**RE: Westgate Mobile Home Park
Site Plan for Building Permit / Drainage Supplement
Engineer's Stamp Date 12-28-2015 (File: L09D44)**

Westgate Mobile Home Park First Flush Retention

Westgate Mobile Home Park – First Flush Retention

RONALD R. BOHANNAN P.E. #7868	WESTGATE MOBILE HOME PARK DRAINAGE BASIN MAP	DRAWN BY VP
		DATE 12/23/15
	 TIERRA WEST, LLC 5571 MIDWAY PARK PLACE NE ALBUQUERQUE, NM 87109 (505) 858-3100 www.tierrowestllc.com	2015099 BASE-GR
		SHEET # C1 JOB # 2015099

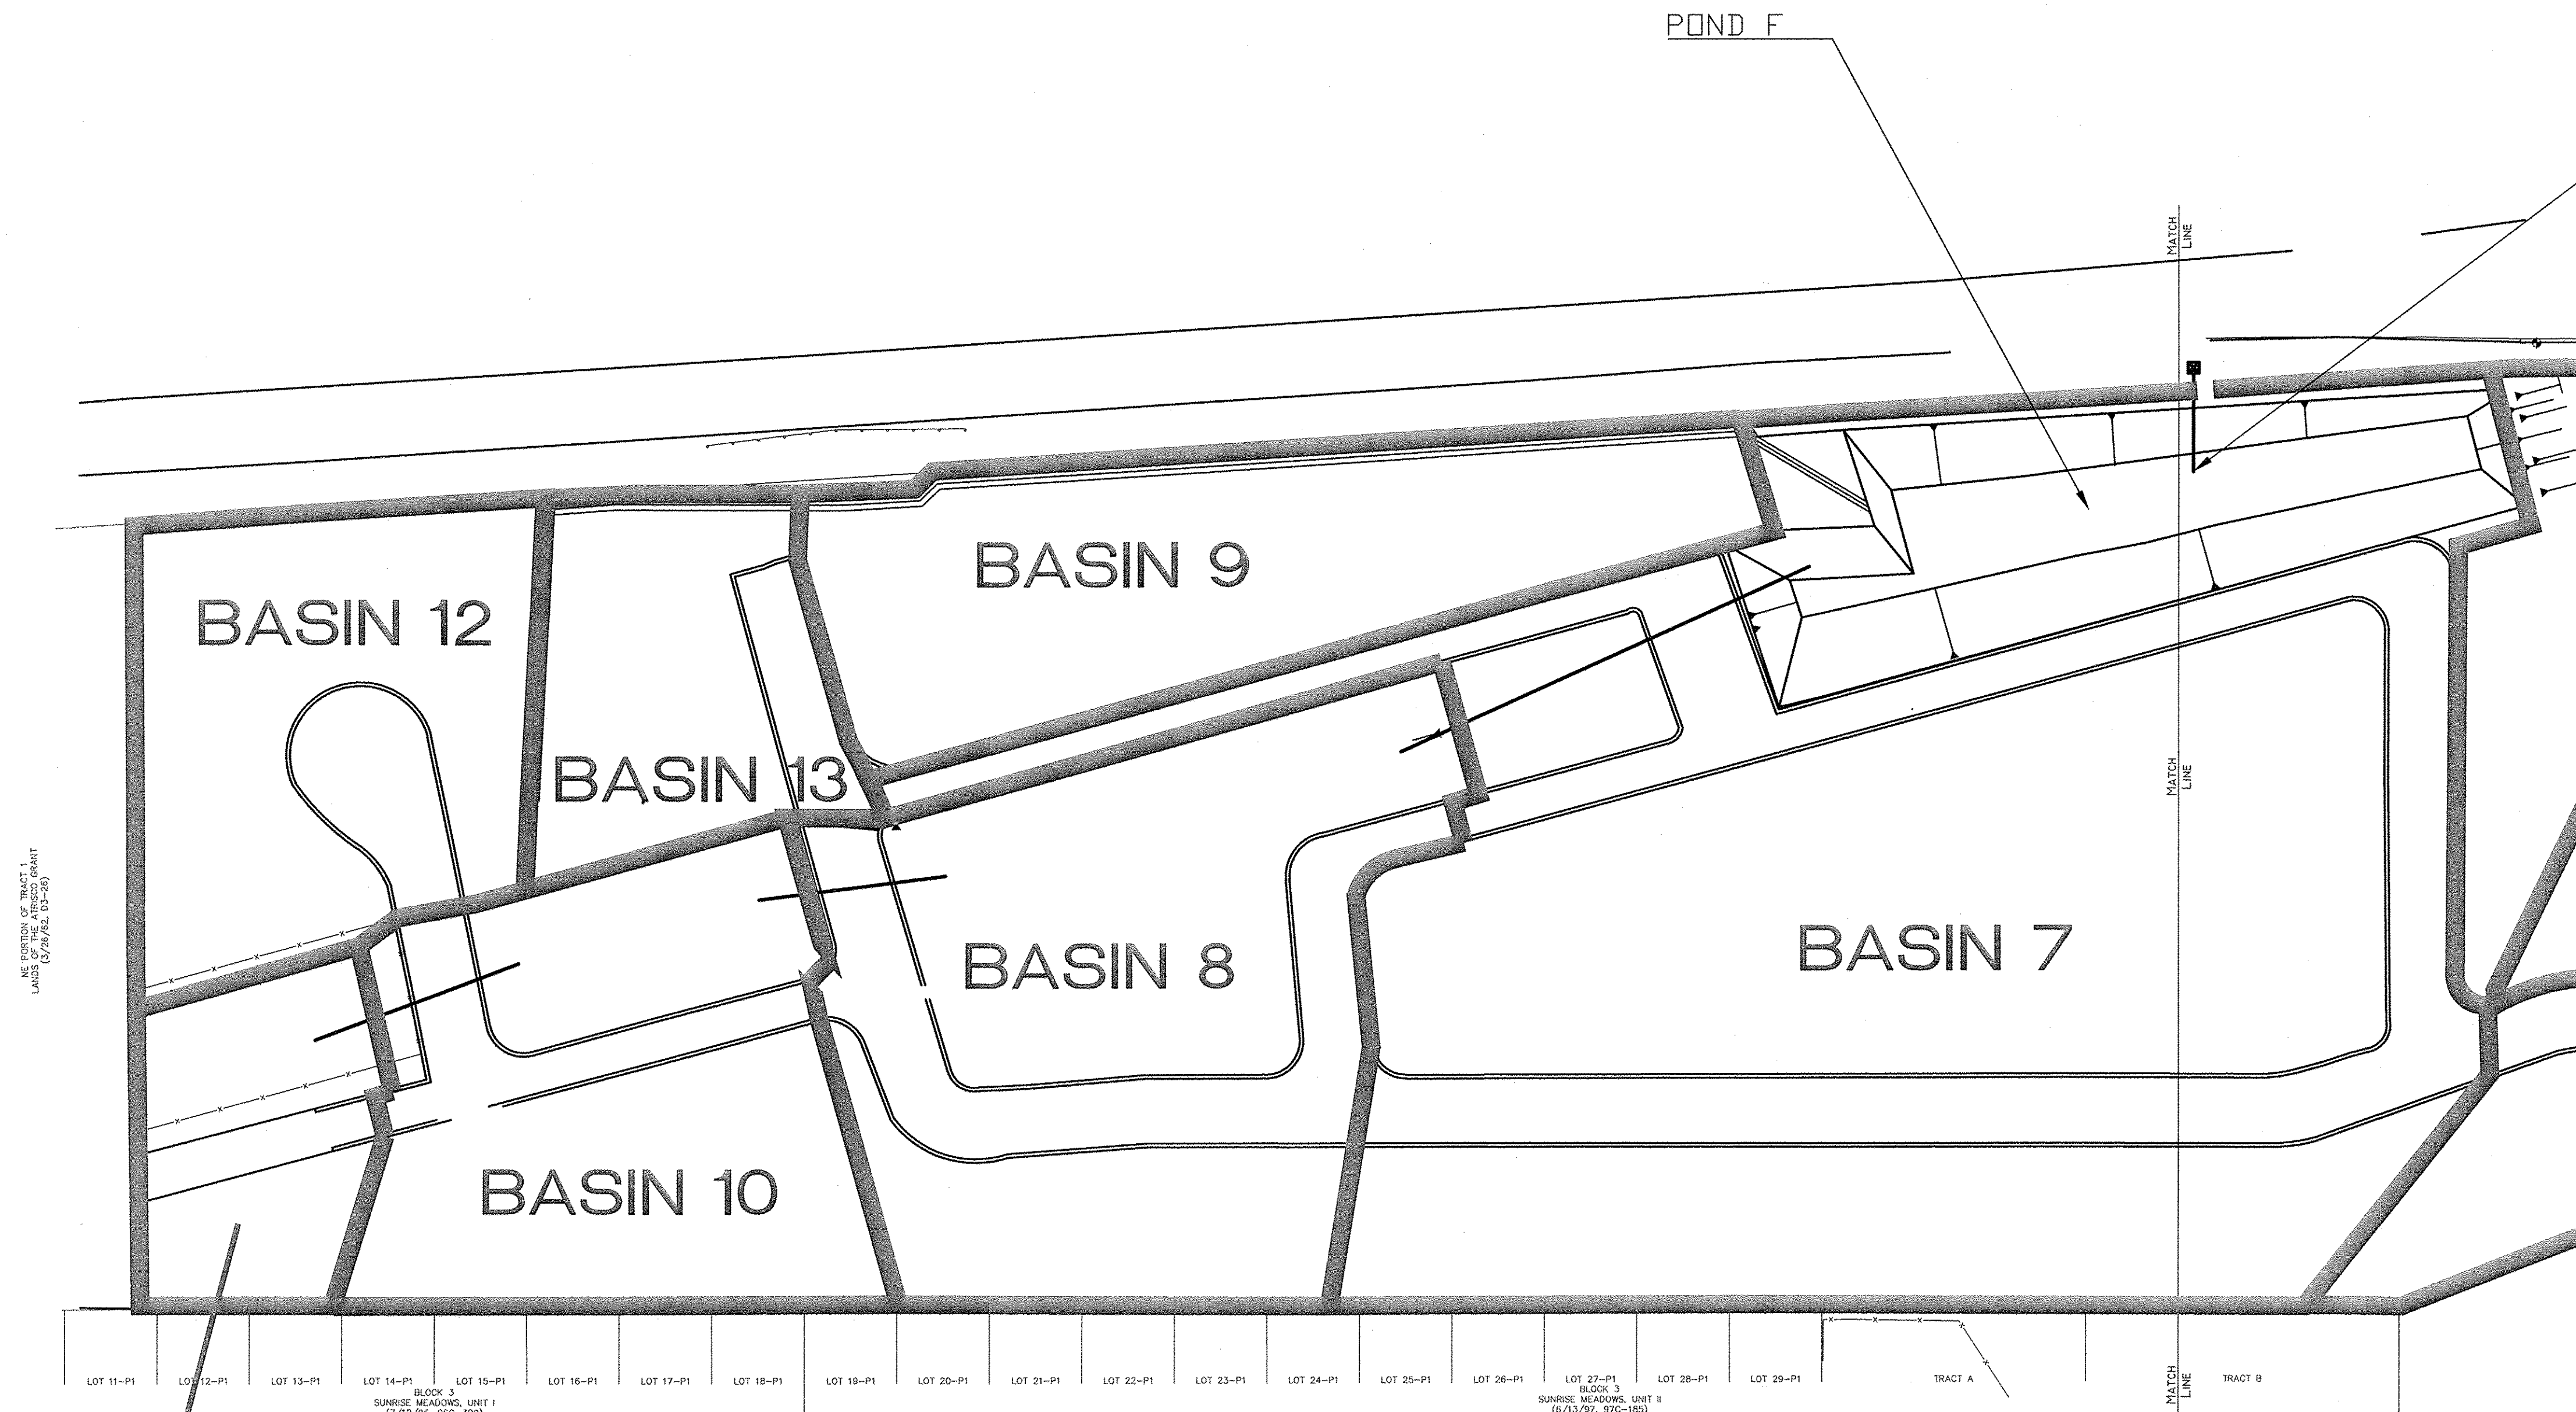
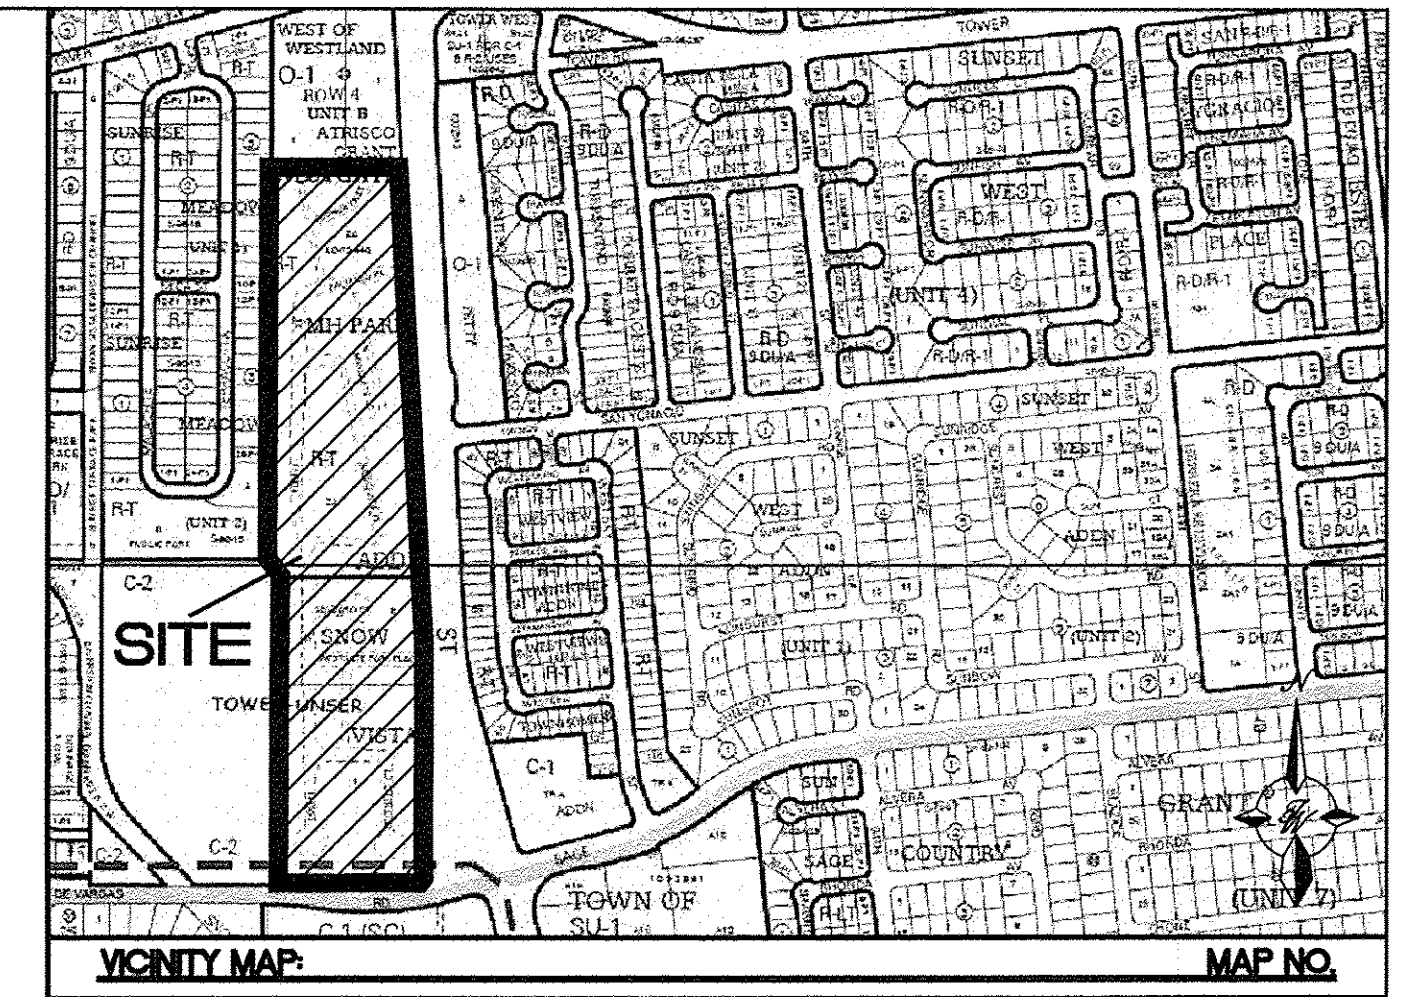
The supplemental drainage submittal and Grading/Drainage plan satisfies Hydrology's requirement from the Development Review Board hearing of 12-9-2015. The condition of final (Site Plan for Building Permit) sign off from Planning was to show the layout of the first flush ponds on the site plan.

RAISE INVERT TO 1' ABOVE EXISTING ELEVATION
